RE: S/D 00-03 -- One-Step Final Plat of STARWEST ADDITION

STAFF REPORT
(One-Step Final Plat Approved 1/20/2000)

CASE NUMBER: S/D 00-03 - STARWEST ADDITION

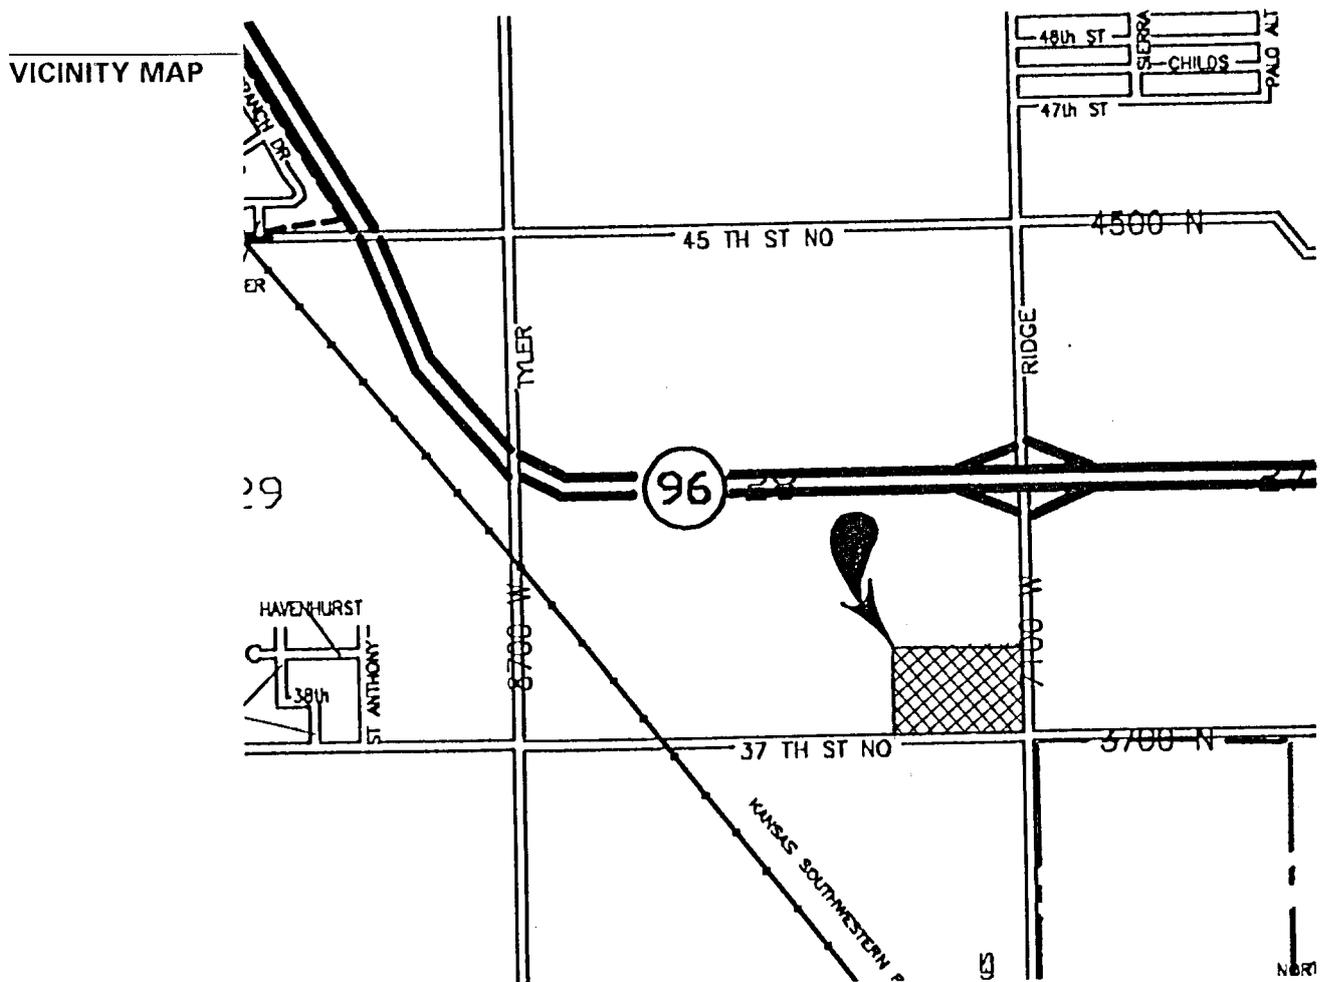
- A. The site is currently located outside of the Northwest Wichita Sanitary Sewer growth limits. The Applicant shall guarantee the extension of City water and sanitary sewer to serve the lots being platted. City/County Engineering needs to indicate the need for any other guarantees or easements. City Engineering has requested a utility easement along the south line of the plat for sanitary sewer. The Applicant shall provide a restrictive covenant prohibiting development until the site can be serviced by sanitary sewer.

- B. If improvements are guaranteed by petition, a notarized certificate listing the petitions shall be submitted to the Planning department for recording.

- C. City Engineering needs to comment on the status of the applicant's drainage plan. The drainage plan is approved. A guarantee is required.
- D. City Engineering needs to comment on the access controls. The plat proposes three access openings along both Ridge Road and 37th St. North in accordance with the approved CUP. The CUP approval also required that the joint openings between Lots 3 and 4 and between Lots 4 and 5 be limited to right turns only, or a guarantee provided for future construction of a raised median if deemed necessary by Traffic Engineering. The dedication of access controls shall be referenced in the plat's text.

- E. This property is within a zone identified by the City Engineers' office as likely to have groundwater at some or all times within 10 feet of the ground surface elevation. Building with specially engineered foundations or with the lowest floor opening above groundwater is recommended, and owners seeking building permits on this property will be similarly advised. More detailed information on recorded groundwater elevations in the vicinity of this property is available in the City Engineers' office.

- F. The final plat tracing shall state in the plat's text the purposes of Reserve A as well as who is to own and maintain the reserve.
- G. The plat's text shall include the standard floodway language.

- H. The joint access openings shall be established by separate instrument.
- I. Provisions shall be made for ownership and maintenance of the proposed reserves. The applicant shall either form a lot owners' association prior to recording the plat or shall submit a covenant stating when the association will be formed, when the reserves will be deeded to the association and who is to own and maintain the reserves prior to the association taking over those responsibilities.

- J. For those reserves being platted for drainage purposes, the required covenant which provides for ownership and maintenance of the reserves shall grant, to the City, the authority to maintain the drainage reserves in the event the owner(s) fail to do so. The

K. A CUP Certificate shall be submitted to MAPD prior to City Council consideration, identifying the approved CUP (referenced as DP-250) and its special conditions for development on this property.

L. The final tracing shall include a note that this plat is subject to the conditions of DP-250.

M. Traffic Engineering should comment on the need for traffic improvements. The CUP required a continuous right-turn decel lane and a left-turn storage lane from the intersection to the major entrance on 37th Street North and the major entrance on Ridge Road. The CUP also required the Applicant to guarantee 12.5% of the cost of signalization of the intersection of 37th St. North and Ridge Road.

N. Traffic Engineering should comment on the need for street improvements. The CUP required a guarantee for paving along the frontage of 37th Street North.

O. In accordance with the CUP, a cross-lot circulation agreement shall be provided which provides at least two points of access from 37th Street North to the property north of the plat.

P. The platlor's text shall include language that a drainage plan has been developed for the plat and that all drainage easements, rights-of-way, or reserves shall remain at established grades or as modified with the approval of the applicable City or County Engineer, and unobstructed to allow for the conveyance of stormwater.

Q. The applicant shall install or guarantee the installation of all utilities and facilities which are applicable and described in Article 8 of the MAPC Subdivision Regulations. (Water service and fire hydrants required by Article 8 for fire protection shall be as per the direction and approval of the Chief of the Fire Department.)
